APPENDIX CC
CAC AND PUBLIC INFORMATION MEETING SUMMARIES

Location	Section 5 Project Office One City Centre - 1st Floor conference room	**Project:**	I-69 Tier 2 EIS – Section 5
Date/Time	November 9, 2004 6:00 – 8:00 p.m.	**Notes Prepared By:**	Kurt Weiss
Subject	Community Advisory Committee (CAC) Meeting # 1

I-69 Evansville-to-Indianapolis
Tier 2 Studies
Section 5
SR 37 to SR 39

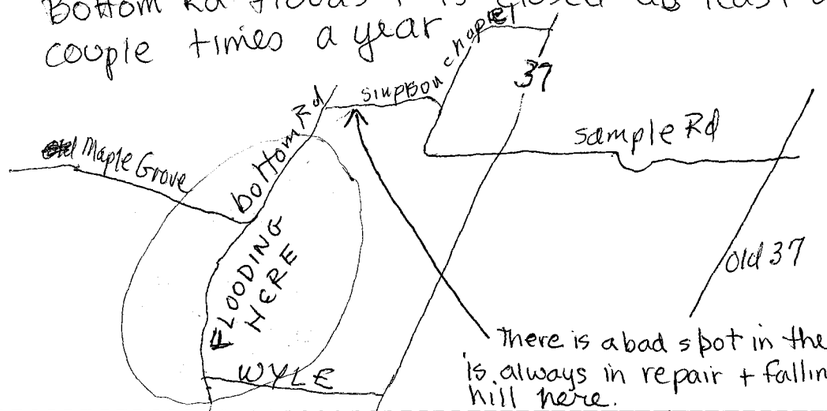
I think this is the best plan for the area where we live. Please be aware that Bottom Rd floods + is closed at least a couple times a year

There is a bad spot in the road that is always in repair + falling down the hill here.

Tell Us Why!

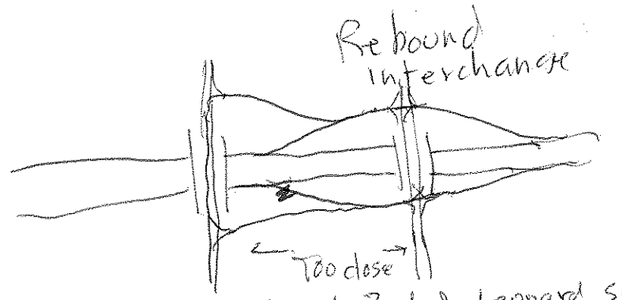
Fix the intersection at 2nd & Leonard Springs

Preferred Alternative 8 Walnut Street Interchange Option A

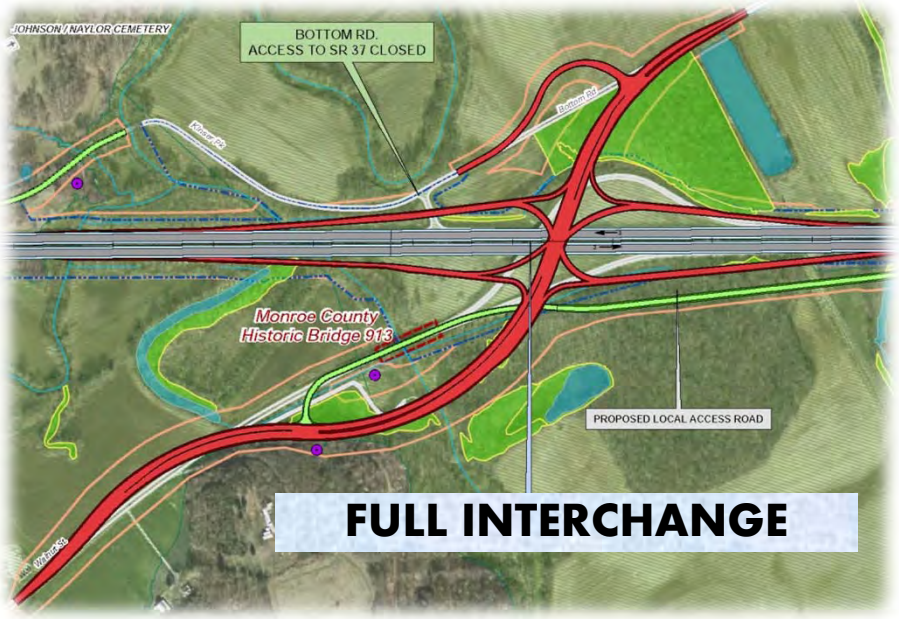
- Addresses FHWA guidelines for full interchanges on new facilities
- Provides I-69 access to/from all directions
- Increased impacts and cost

Preferred Alternative 8 Walnut Street Interchange Option B

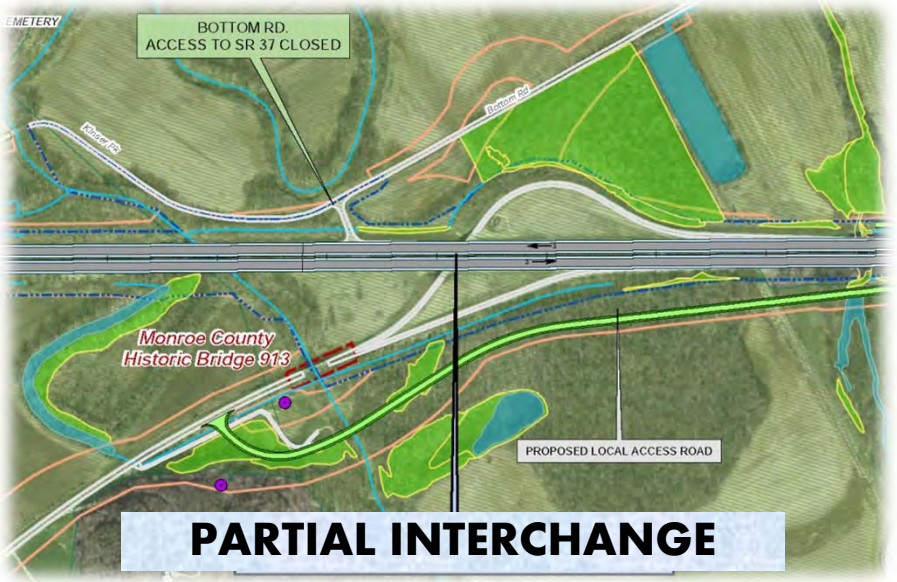
- Fewer impacts than full interchange
- Saves $45M over full interchange
- Use not yet approved by FHWA
